1. AGENCY USE ONLY <i>(Leave Blank)</i>	2. REPORT DATE 02/00/90	3. REPORT TYPE AND DATES COVERED DRAFT FINAL	
4. TITLE AND SUBTITLE DRAFT FINAL DECISION DOCUMENT FOR THE INTERIM RESPONSE ACTION AT THE MOTOR POOL AREA ROCKY MOUNTAIN ARSENAL, VERSION 3.1		5. FUNDING NUMBERS DAAA1588D0022

DRAFT FINAL DECISION DOCUMENT
FOR THE INTERIM RESPONSE ACTION
AT THE
MOTOR POOL AREA
ROCKY MOUNTAIN ARSENAL
FEBRUARY 1990
CONTRACT NO. DAAA15-88-D-0022/0002
VERSION 3.1

RESPONSE TO EPA'S COMMENTS
ON THE PROPOSED DECISION DOCUMENT
FOR THE INTERIM RESPONSE ACTION
AT THE MOTOR POOL AREA, VERSION 2.0
NOVEMBER 1989

TCE SOIL GAS PLUME 1989 FIELD INVESTIGATION MOTOR POOL AREA

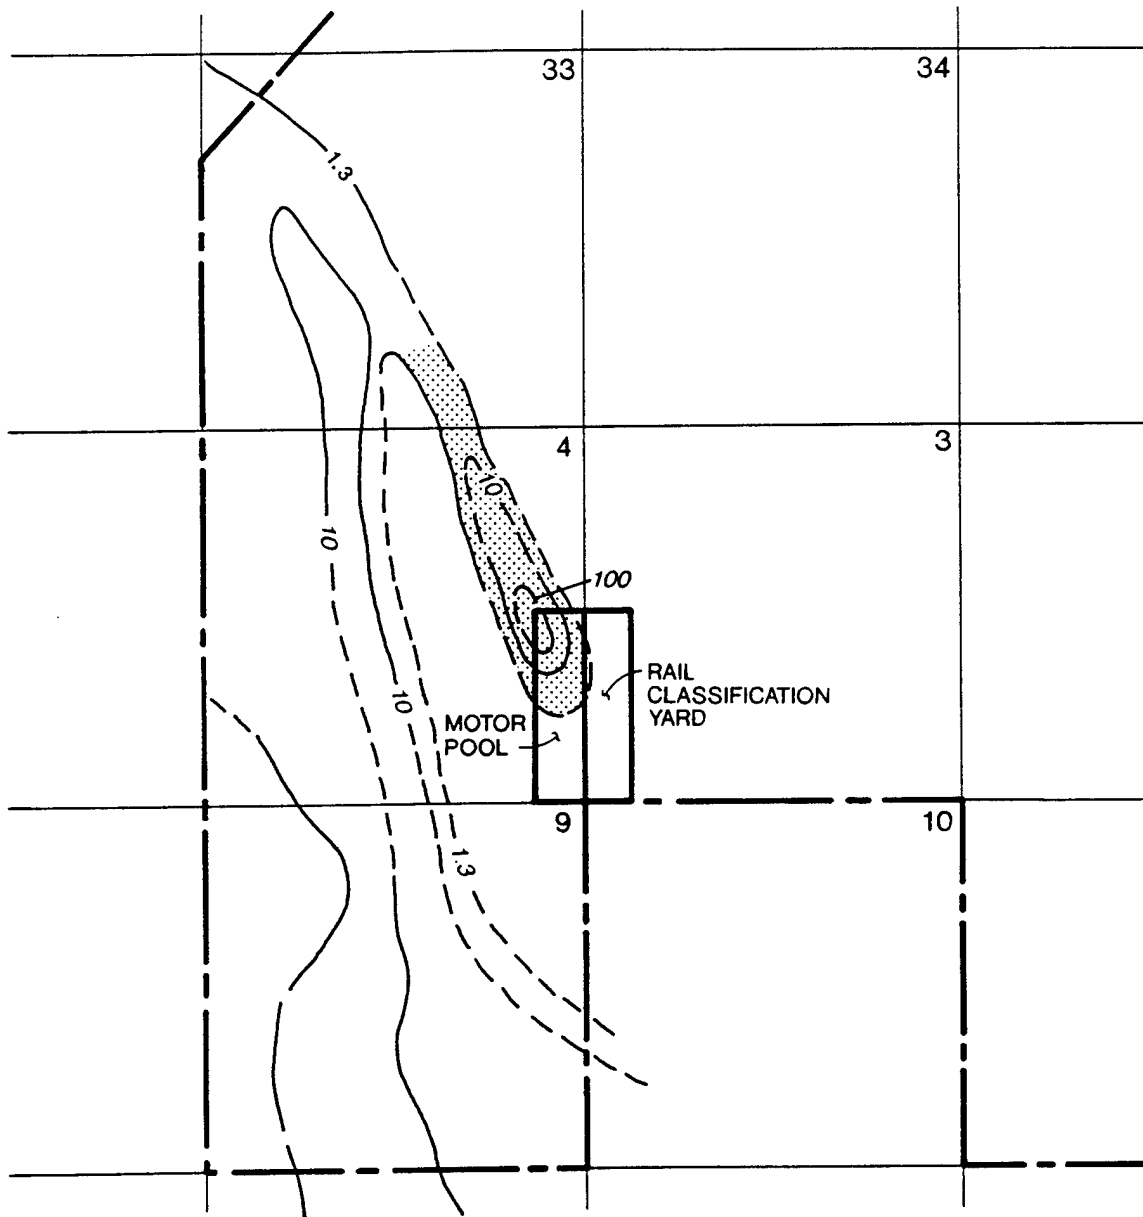
Comment 2: Units of concentration from the soil gas survey should be applied to the concentration lines on Figure 2-3.

Comment 7: In Figure 2-3, the soil gas concentration contours do have units. If the units are ug/l gas, then there appears to be an approximate order of magnitude discrepancy between values reported in this study and the Ebasco investigation (see Figures 2-17, results of field and laboratory investigations conducted for the remediation of other contamination sources).

Response: The figure has been revised.

Response: Soil gas is a fairly qualitative method of identifying possible sources of contamination. Both investigations indicate a contamination source in the same vicinity. However, soil contamination concentrations cannot be quantitatively inferred from soil gas results.
